Designs for a THREE TEACHER RURAL SCHOOL

With Teachers' Cottage

REPORT OF THE JURY OF AWARD OF THE SIXTH ANNUAL WHITE PINE ARCHITECTURAL COMPETITION

Judged at Yama Farms, Napanoch, N. Y., May 6 and 7, 1921

FIRST PRIZE DESIGN
Submitted by Antonio DiNardo and W. Frank Hitchens, Pittsburgh, Pa.

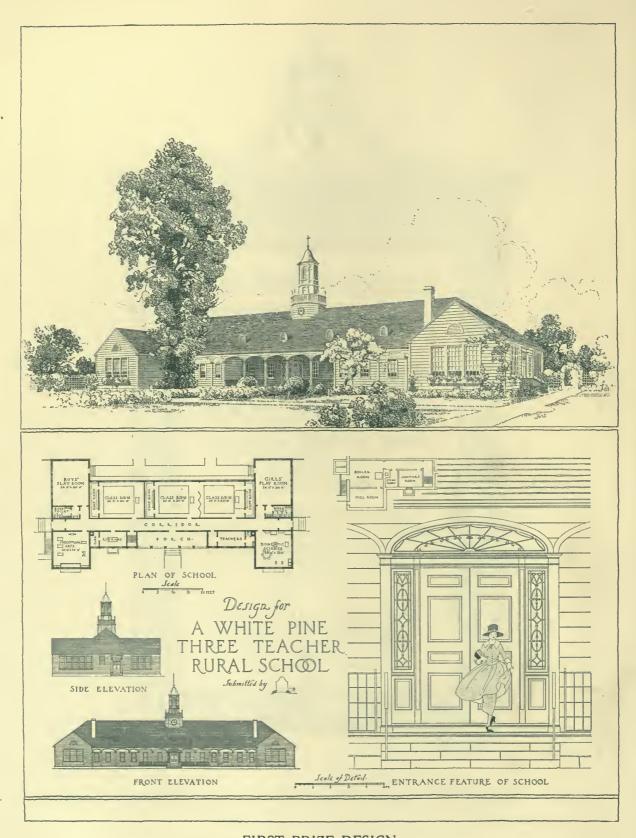
FIRST PRIZE DESIGN. Submitted by Antonio DiNardo and W. Frank Hitchens, of Pittsburgh, Pa. Architecture, being a three-dimensional subject, cannot be considered otherwise, and, therefore, it becomes not a question of plan or elevation, but a question of plan and elevation. This design had a well articulated plan which functioned admirably, and an elevation possessing the charm of light and shade and shadow. The "porch," both as a practical and as an æsthetic feature, is attractive.

SECOND PRIZE DESIGN
Submitted by William D. Foster, New York, N. Y.

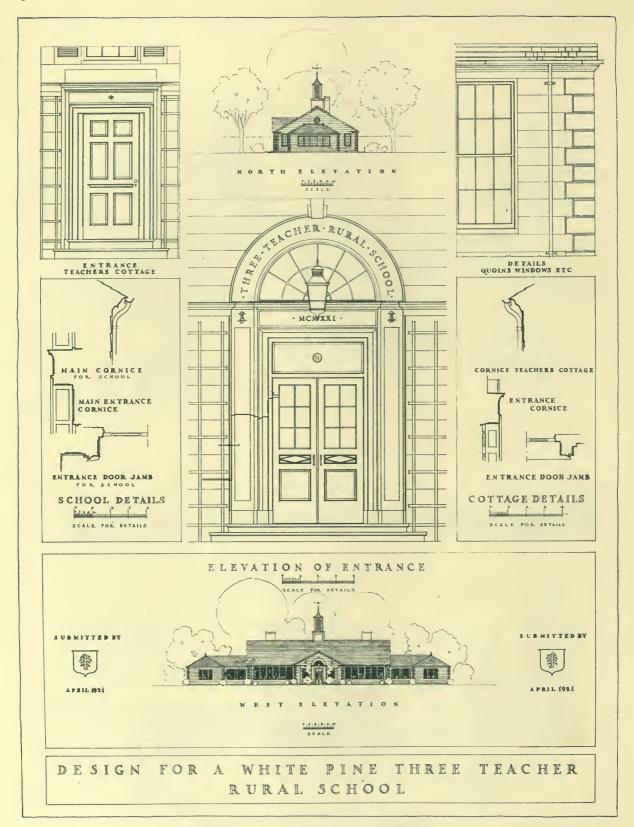
SECOND PRIZE DESIGN. Submitted by William D. Foster, of New York, N. Y. As between the design placed first and that placed second, there was no great difference in merit. The ample sunlit corridor presents an attractive feature excelled by no competitor. The plan turns the most attractive elevation of the building away from the Village Green. The location of the play rooms and their correlation with the out-of-door play spaces and toilets, the location of the special rooms with respect to the class rooms, are admirable features of this fine open plan.

The one-story teachers' cottage is attractive exteriorly, but not well studied as to plan, the living room being turned, necessarily, into a runway, interfering with its use as a center of social life. The kitchen is not any too well equipped with pantice or storage electes.

Submitted by Chauncey F. Hudson, Buffalo, N. Y.

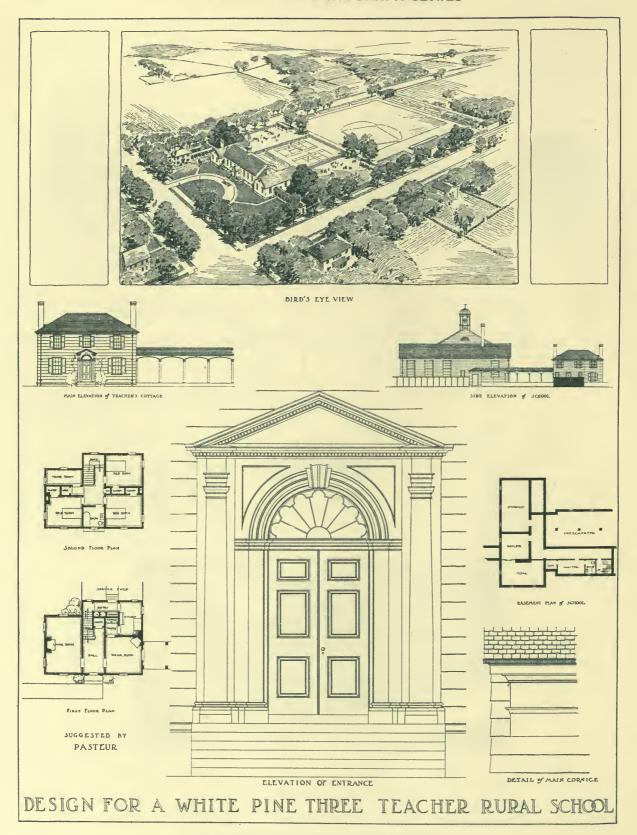
THIRD PRIZE DESIGN. Submitted by Chauncey F. Hudson, of Buffalo, N. Y. This plan fell into the interior corridor type, and so loses somewhat of the attractiveness of the first and second prize designs. Nor do the toilet and play rooms, as to arrangement, quite reach the standard set by those designs. The location of the special rooms—industrial arts and domestic

science—is not as good as in the two preceding plans. The character of the exterior is rich in quiet, rural charm, lacking in too many of the designs submitted.

FOURTH PRIZE DESIGN Submitted by Robbins L. Conn, New York, N. Y.

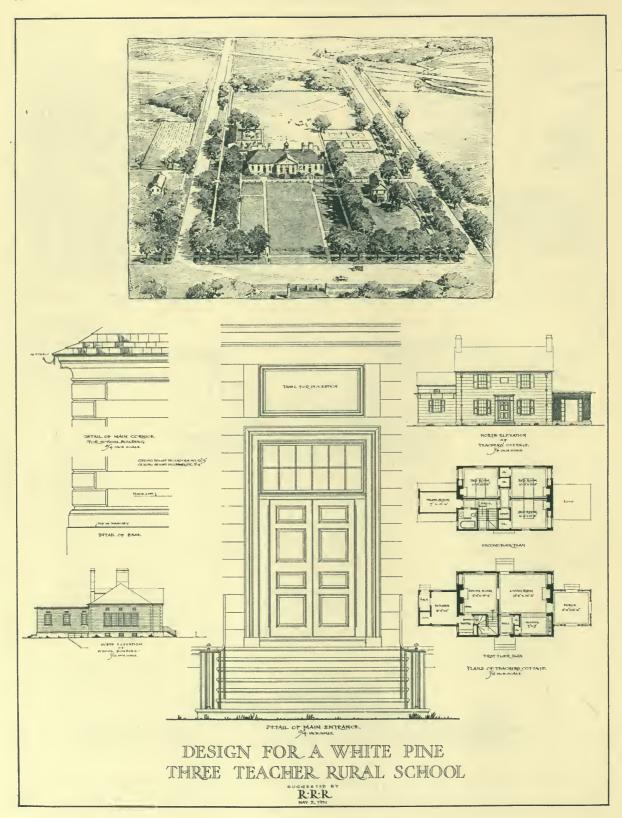
FOURTH PRIZE DESIGN. Submitted by Robbins L. Conn, of New York, N. Y. Like the design placed third, a long interior corridor was introduced into this design. The relation of the play rooms and toilets to the special rooms is good, as is also the correlation of the library and of the teachers' room with the class rooms. Also, like the third prize design, the elevations adequately express that which is most characteristic of rural surroundings, a leisurely charm.

SECOND MENTION Submitted by David W. Carlson and Emil A. Lehti, New York, N. Y.

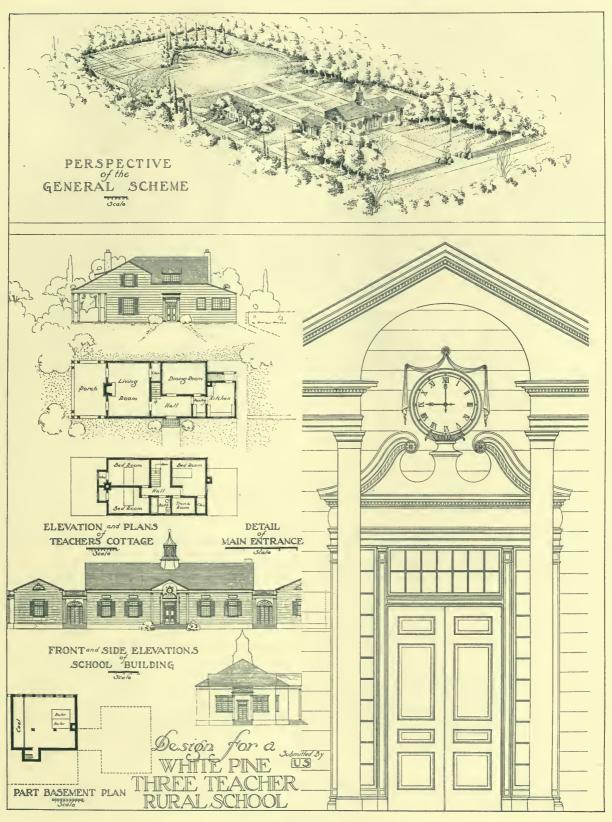
SECOND MENTION. Submitted by David W. Carlson and Emil A. Lehti, of New York, N. Y. Of the designs to receive Mention, of which there were six, two seemed worthy of being given a definite place, and the Jury takes pleasure in according them this recognition. The First Mention is quite "academic" in design, that is, suggestive of the old "academies," yet rural in character; while the Second Mention has a decidedly free and picturesque quality. The interior toilet in connection with the teachers' room in this design is a blemish in the plan which a bit of practical surgery might remove. The setting of the "academic" design is attractive.

Submitted by William J. Mooney and Harold A. Rich, Boston, Mass.

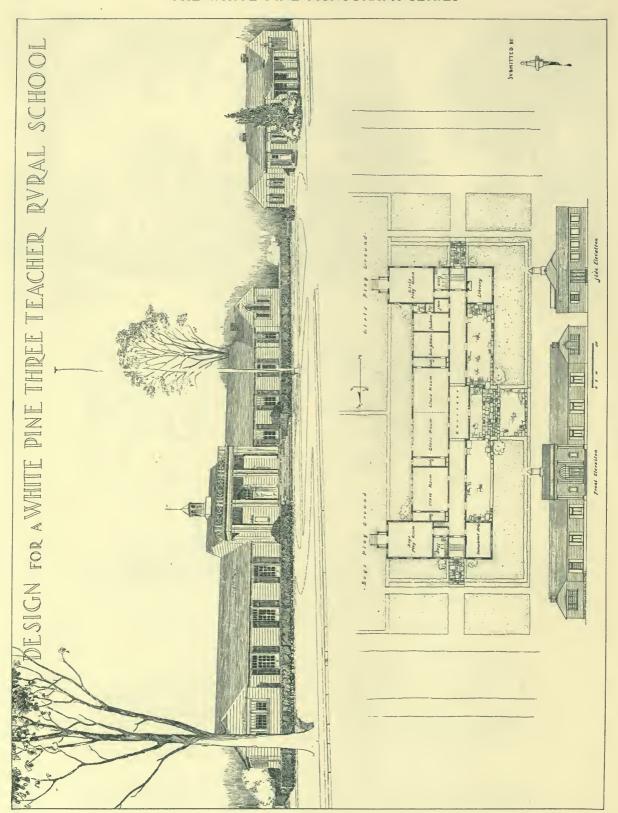
The design submitted by Messrs. Mooney and Rich was the simplest and most appropriate of the designs which featured a tower, of which there were six in the competition. The plan is compact and well arranged, its principal weakness, except for the cramped vestibule, lying in the dark corridor terminating in the toilet rooms rather than in points of light. An otherwise dark corridor may be saved and even made attractive by opening up the ends to the light.

MENTION Submitted by Charles H. Dornbusch and Erick N. Kaeyer, New York, N. Y.

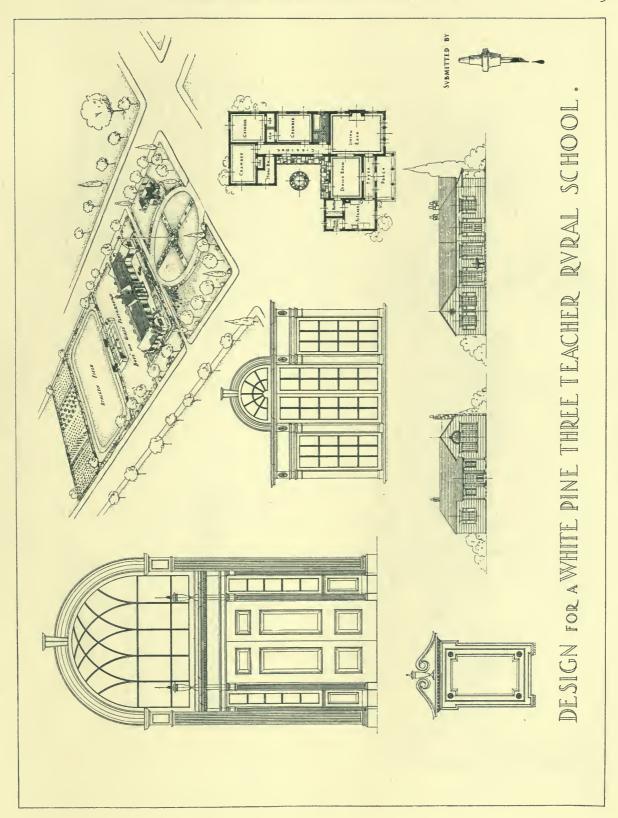
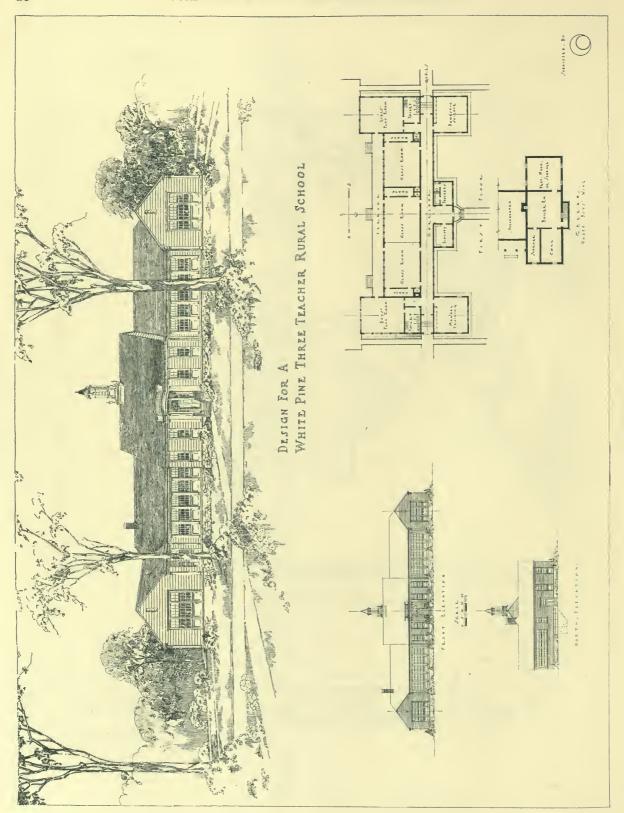
The design submitted by Messrs. Dornbusch and Kaeyer, while extremely attractive in its terraced approaches, suffers from a lack of relationship between the wings, and a central feature which is attenuated and inadequate. The corridor is satisfying. Mr. Harbach's design is good of its type, with a well considered plan, and an

MENTION
Submitted by Leon H. Hoag, Bloomfield, N. J.

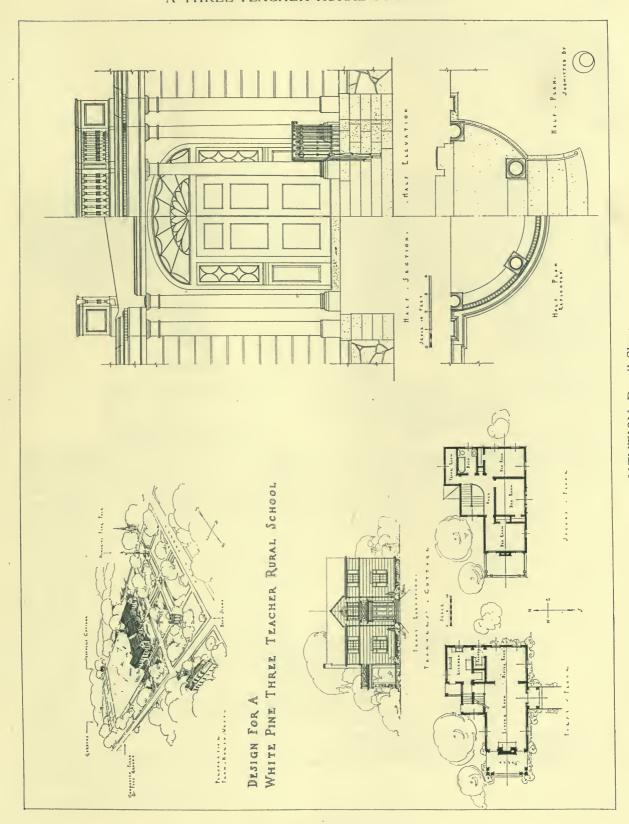
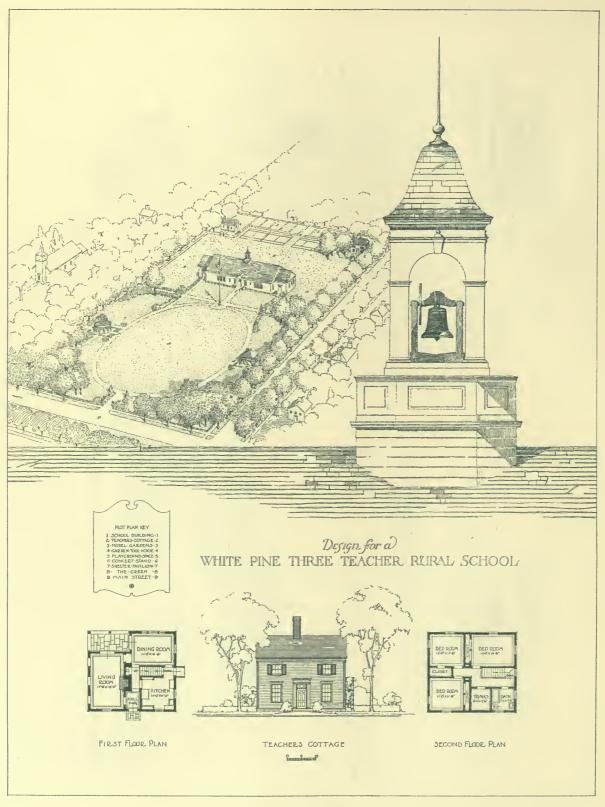
exterior well balanced, but not too replete with points of interest. Mr. Leon H. Hoag's design, concluding the list of those to receive mention, has many good points in plan, together with an exterior which would have been much more attractive and effective had its rather ænemic porch been made to hold its own with the unnecessarily expansive grouped windows of the corridor.
